TOWN OF FAIRFAX STAFF REPORT

TO: Fairfax Planning Commission
DATE: October 21, 2021
FROM: Linda Neal, Principal Planner
LOCATION: 169 Ridgeway Avenue; APN # 001-280-01
PROJECT: Modification of a previously approved project for a single-family residence
ACTION: Modification of Hill Area Residential Development, Ridgeline Development and Design Review permits; Application # 20-13
APPLICANT: Dylan Riley
OWNER: Susan and Dylan Riley
CEQA STATUS: Categorically Exempt, §§ 15303(a) and 15332

169 RIDGEWAY AVENUE

The proposed modifications to the originally approved project are minor but require the approval of the Planning Commission, and consist of the following:

FLOOR PLAN 1/4" = 1'-0"

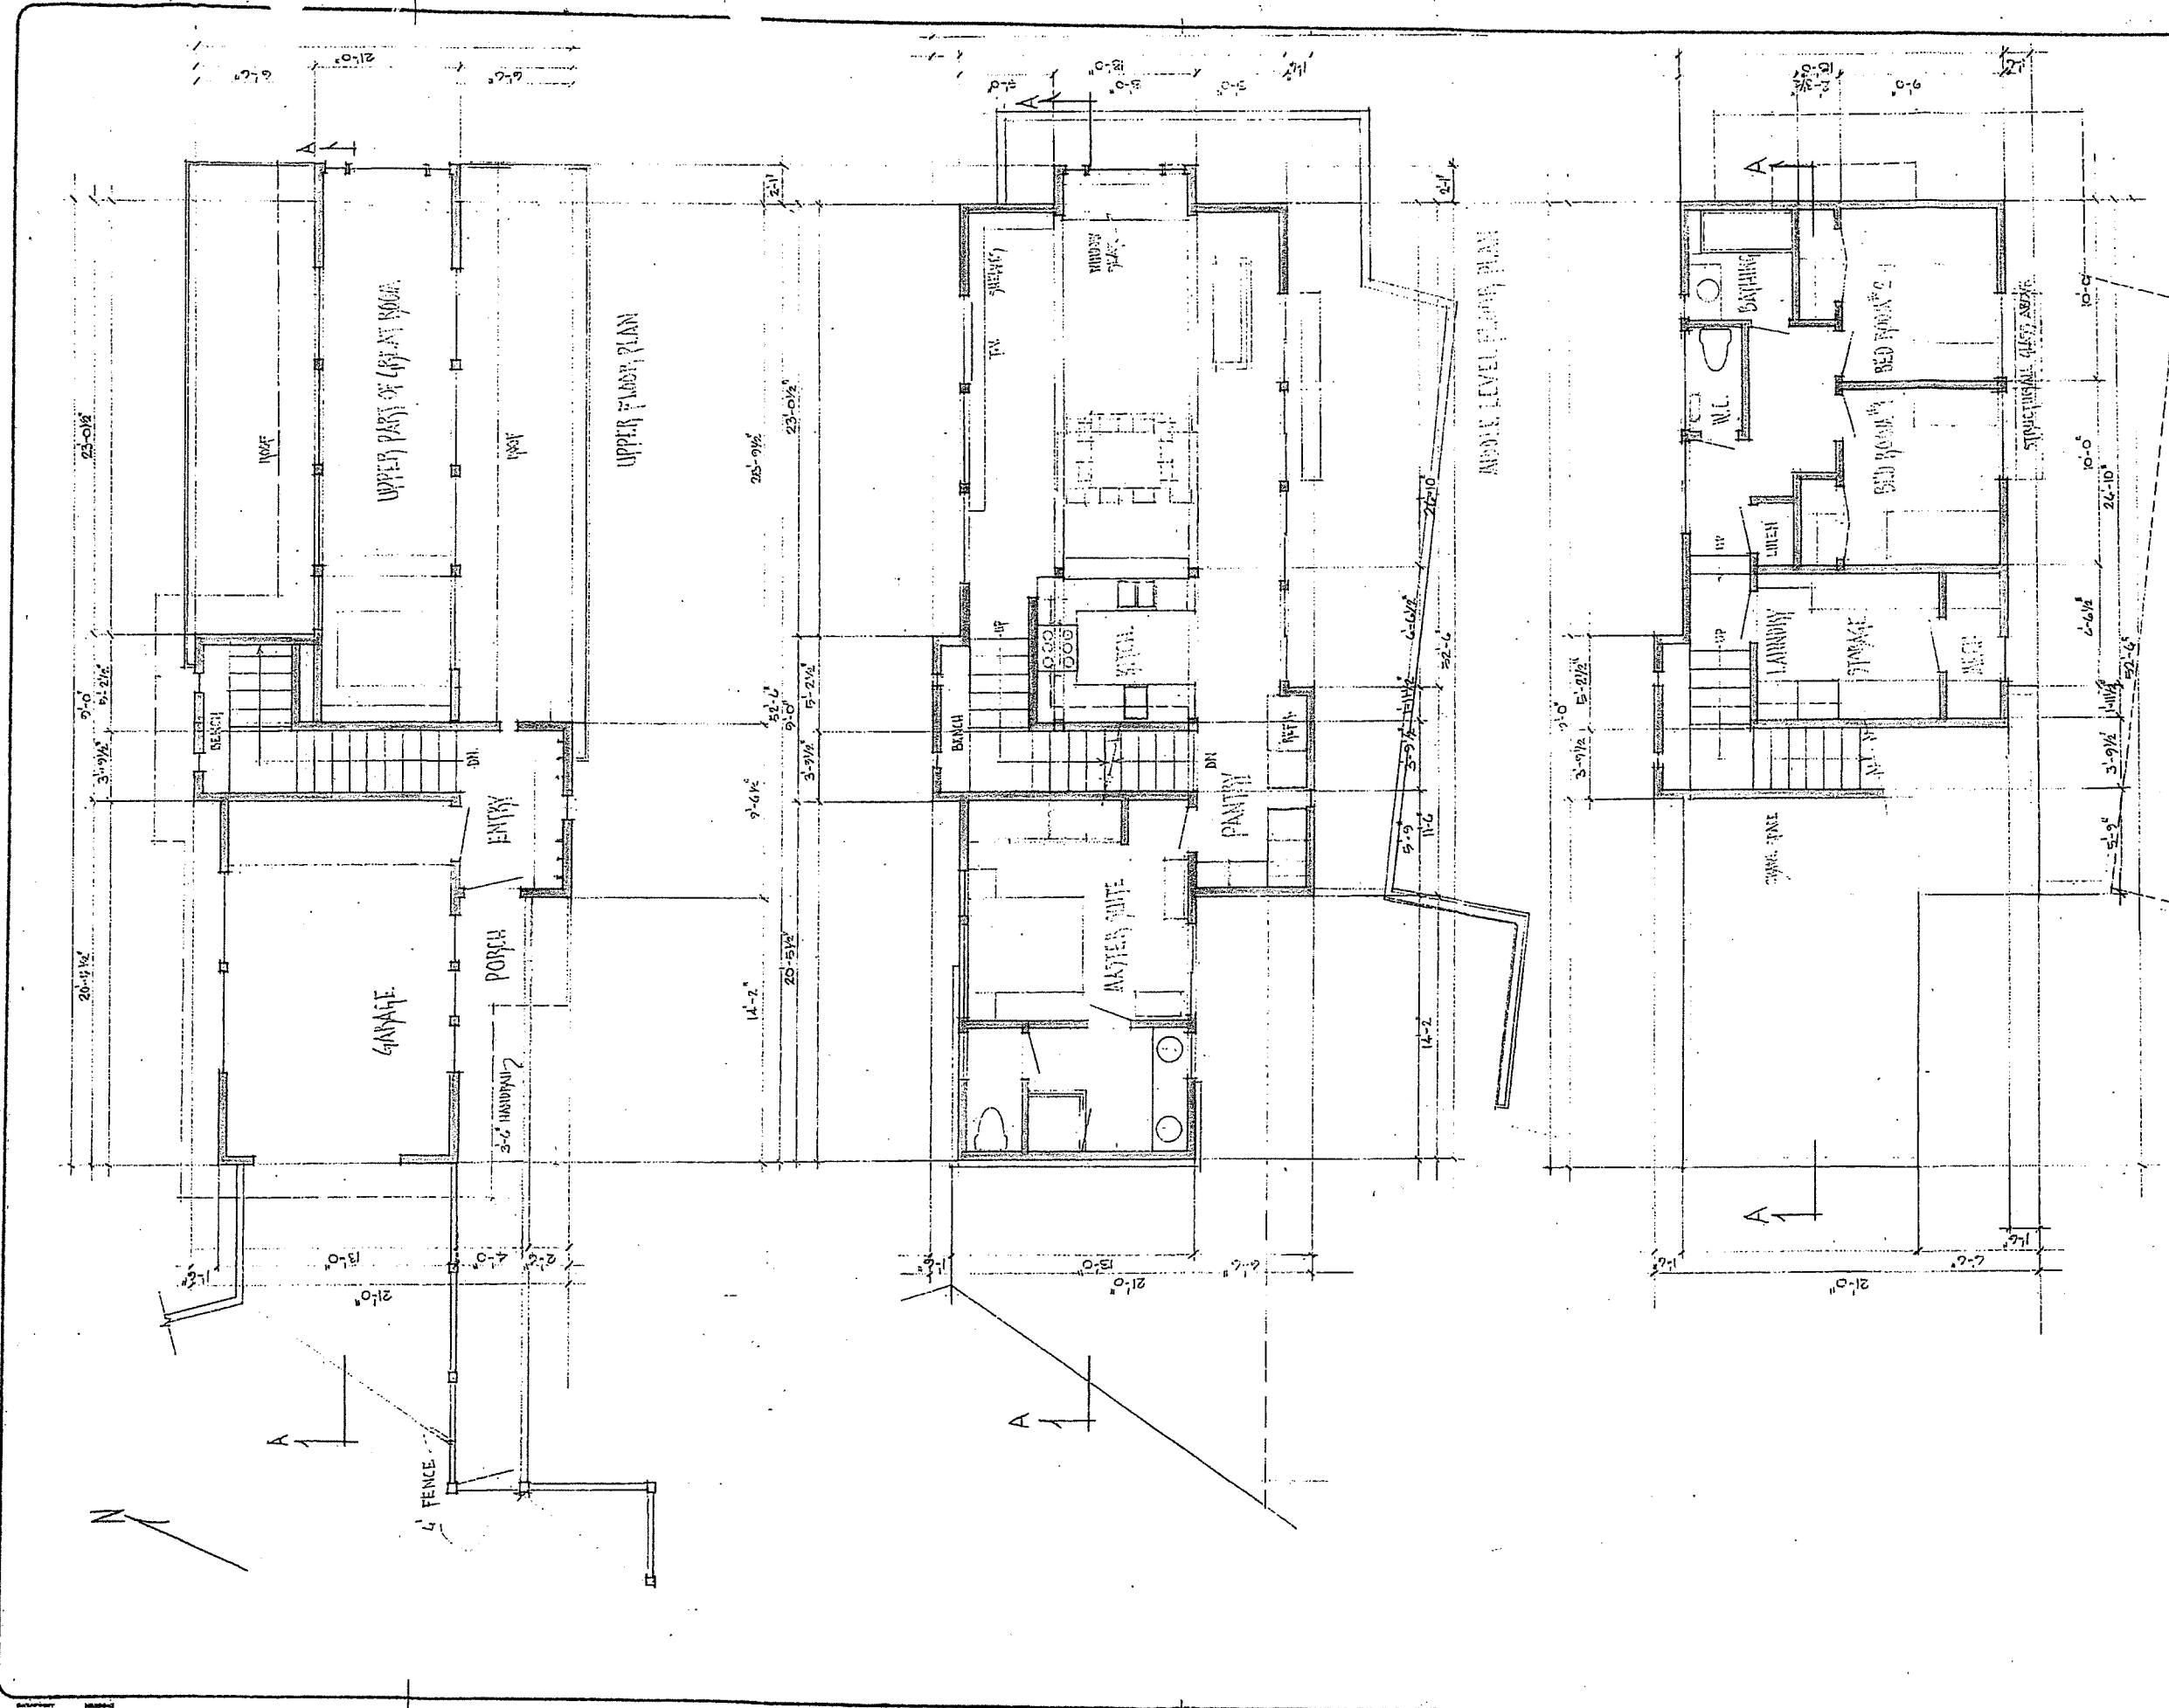
The floor plan of the first level of the residence has been modified with the laundry room decreased in size and the storage room and the mechanical room combined into a larger study room while the mechanical room has been shifted to the south, the eastern wall of the mechanical room has been moved one and one half feet closer to the east side property line (maintaining a minimum side setback of 12 feet and a combined of 22 in compliance with code) and is now located beneath the master bedroom.

The relocation will increase the excavation amount for the project from 38 cubic yards, by roughly 4 cubic yards, bringing the total excavation amount to approximately 42 cubic yards which, when added to the fill amount of 28 cubic yards which is unchanged, results in a total excavation/fill amount of 70 cubic yards, with an off-haul of 14 cubic yards. Excavation/fill amounts less than 100 cubic yards do not require an excavation permit from the Planning Commission per Town Code § 12.20.080.

NORTH ELEVATION

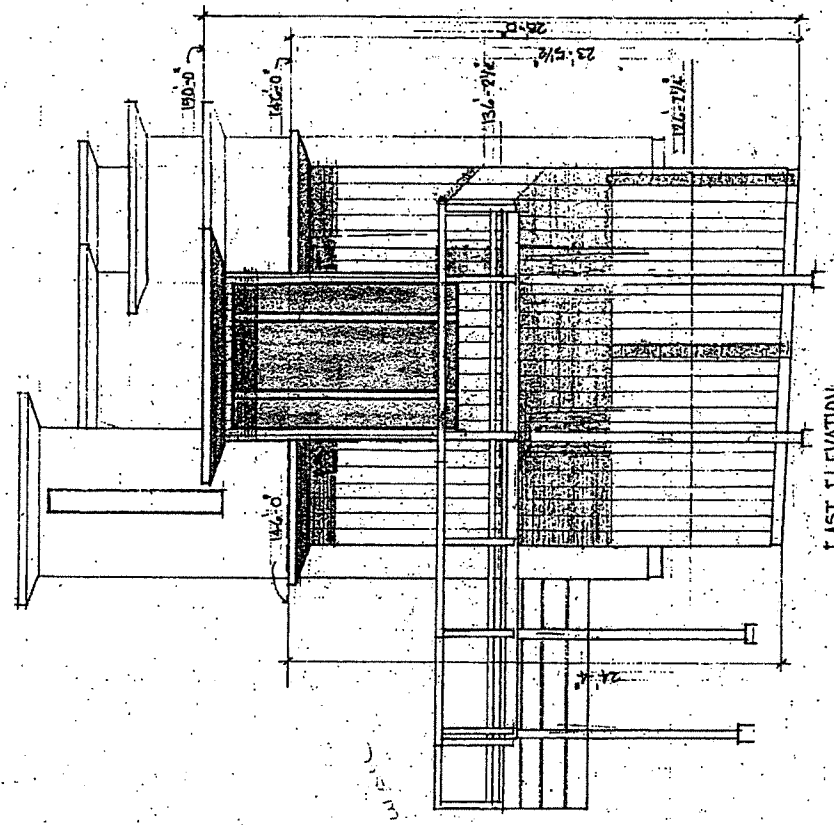
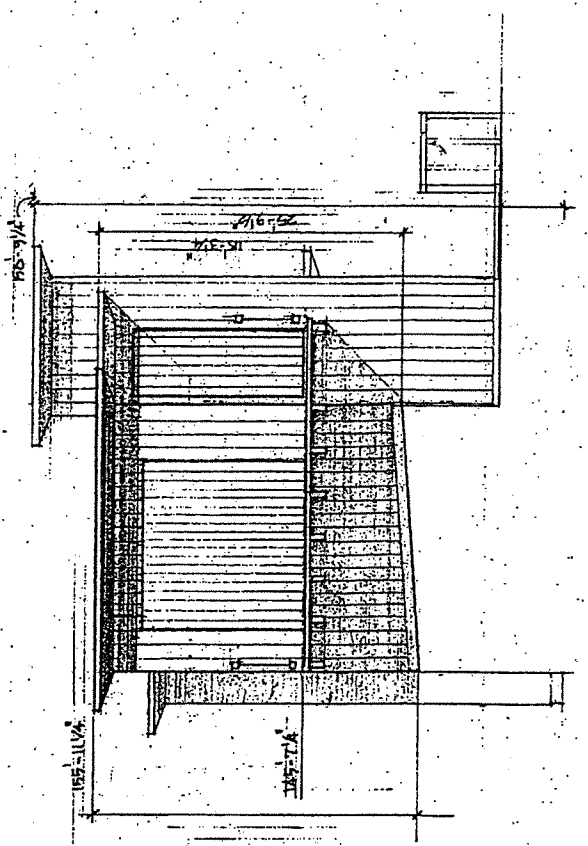
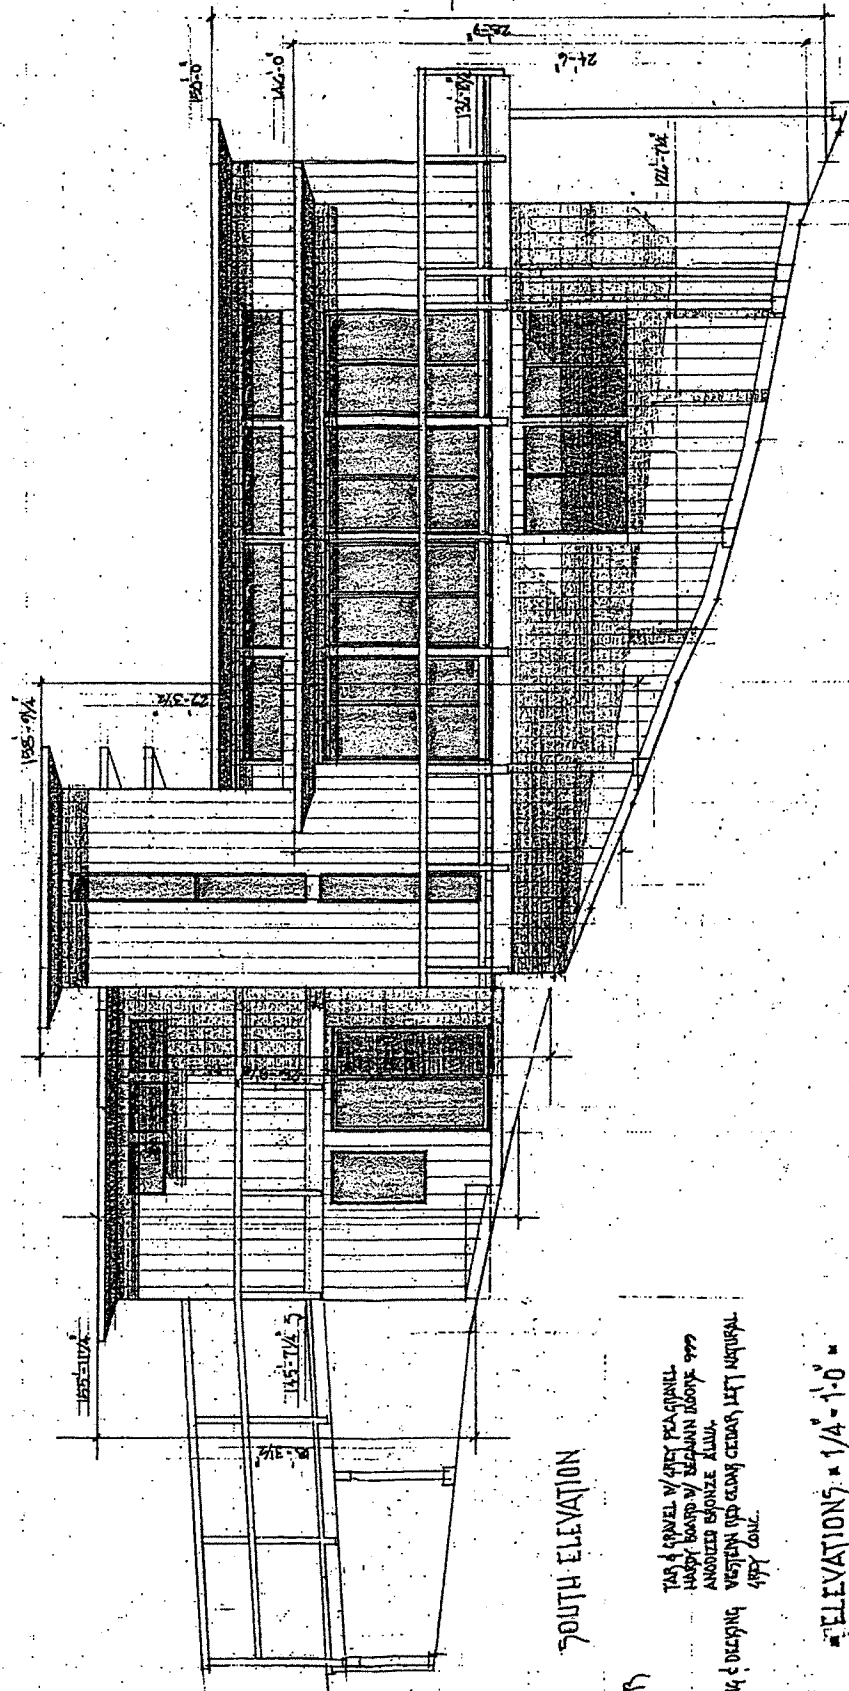
The number of windows and their spacing has increased in the south elevation, and minor changes are proposed to the windows of the stairway tower on the east and west sides of the building. The total window area has not changed. Two new doors are proposed on the east side to provide access into the study and the relocated mechanical room.
